Application Number: 2014-051 **Application Date:** 04/11/2014
CBL: 013 I025001 **Application Type:** Level III Site Plan Under 50,000 sq f
Applicant: DUGAS PETER C & ANASTASIA ANTONACOS JTS /Peter Dugas
Project Name: New 5 unit multi-family building
Address: 97 CUMBERLAND AVE
Project Description: New 5 unit multi-family building.
Zoning: R6

To: Stuart O'Brien, Chair and Members of the Portland Planning Board
From: Jean Fraser, Planner
Date: May 23rd, 2014
Re: **May 27th, 2014 Planning Board Workshop**
 Level III Site Plan and Subdivision Review
 5-unit multi-family building
 97 Cumberland Avenue
 Peter Dugas, Applicant

TO: Jean Fraser, Planner
FROM: David Senus, P.E.
DATE: May 5, 2014
RE: 97 Cumberland Ave Multi-family, Level III Site Plan Application

SHEET 3 OF 5

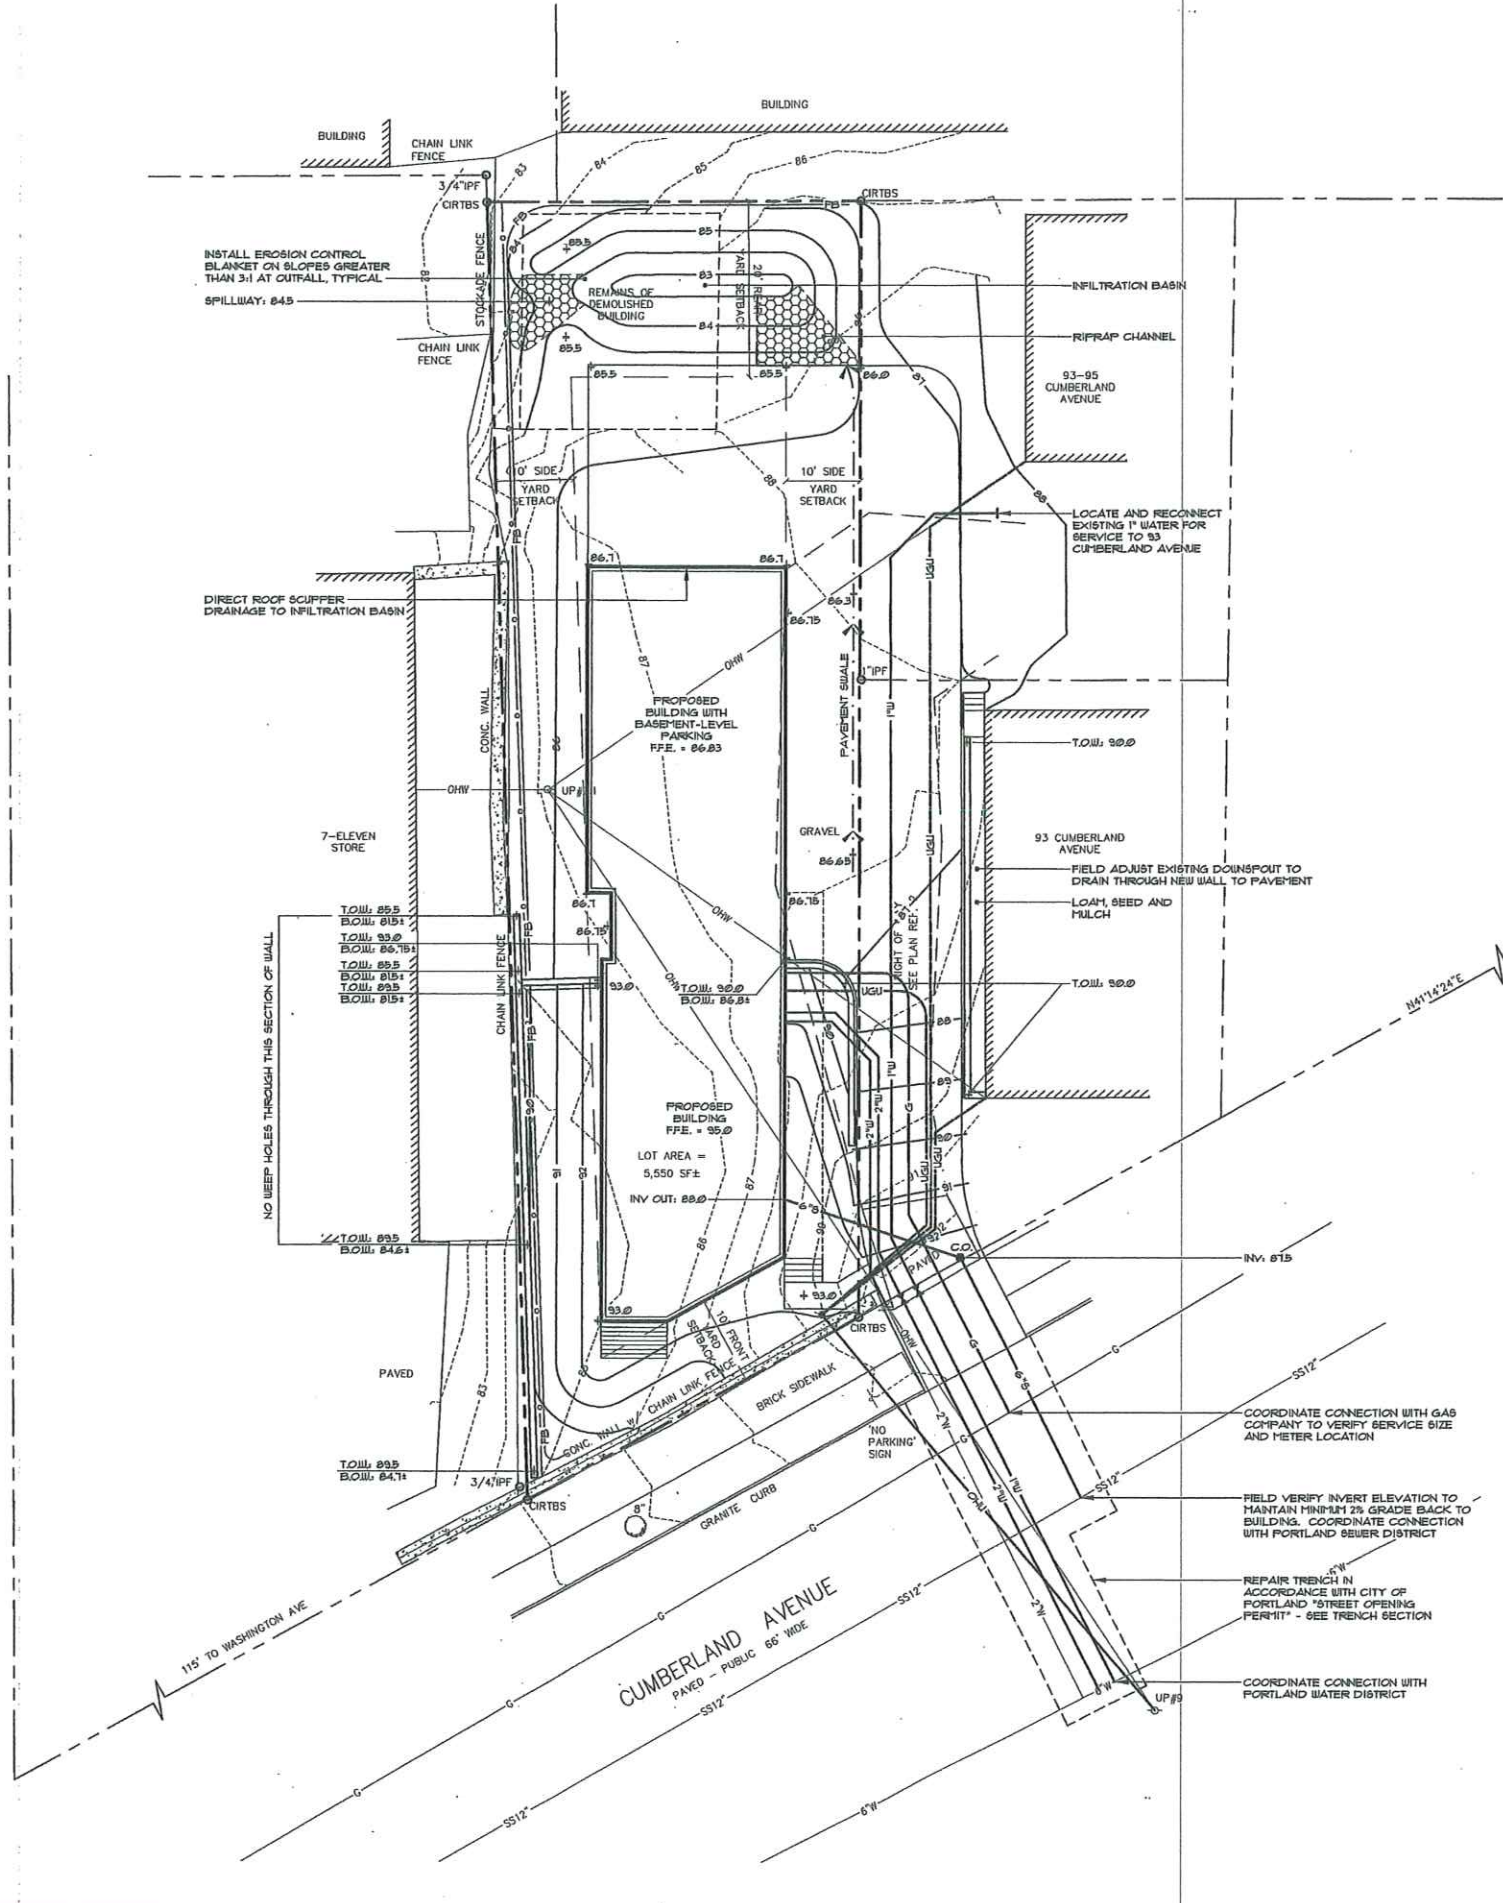
- 9) The Grading and Utility Plan (Sheet 3 of 5) proposes grading well onto the lot that is N/F Kristine McCarthy (93-95 Cumberland); however, no finish surface is specified and it is unclear if the Applicant has rights to perform this work.
